SB TMG 651-1004 P1, Rev. 2

SERVICE BULLETIN

Subject: Start Monitoring Loom and Mapping
Starter Info Board and mapping

Type affected: All Piper PA 28 with TAE 125-02 and Dual Mass Flywheel (DMF)

Figure 1a

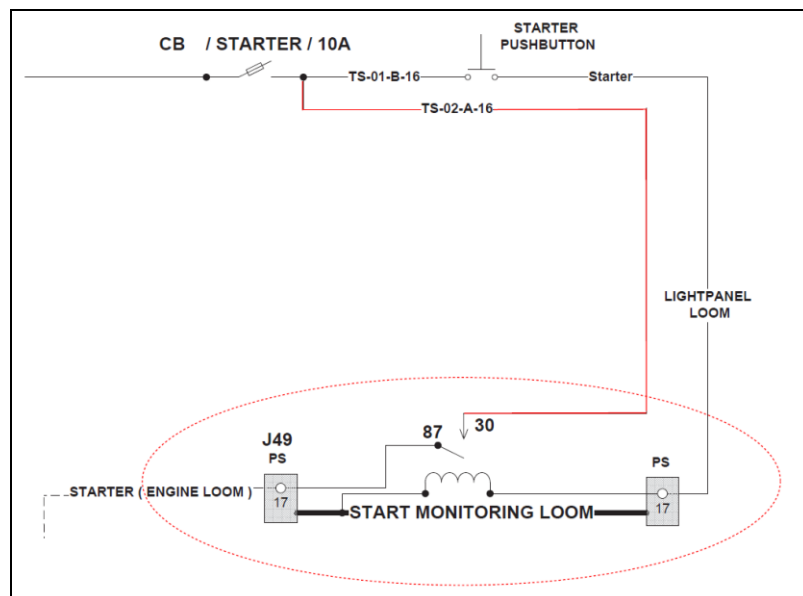
- Install the appropriate start monitoring loom behind the cockpit panel between light panel loom and engine loom in accordance with Figure 1a.

- Attach the start monitoring loom along existing cable bundles.
- Connect the main, excitation and FADEC backup battery.
- Install the new engine firmware TAE-125m3.30 (D48 FADEC) resp. D4-140 (D4 FADEC) or later version plus A/C related mapping. See TM TAE 000-0007

Figure 1b

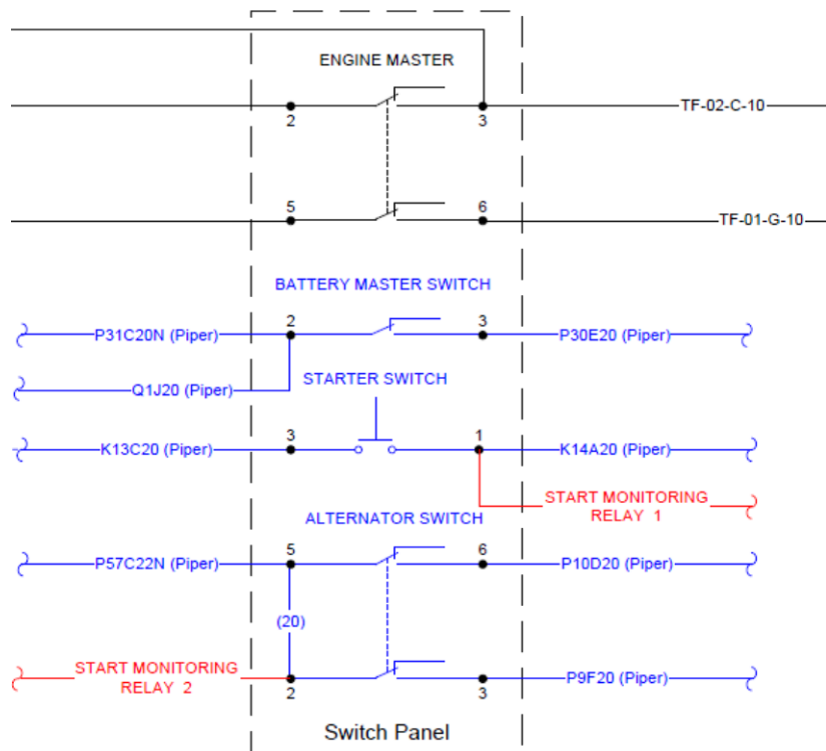
- Install the Starter Info Board in the Overhead Switchpanel in accordance with Figure 1b and Figure 1c.

- Bundle the wires of the Overhead Switchpanel with cable ties.
- Connect the main, excitation and FADEC backup battery.
- Install the new engine firmware TAE-125m3.20 (D48 FADEC) resp. D4-140 (D4 FADEC) or later version plus A/C related mapping. See TM TAE 000-0007.
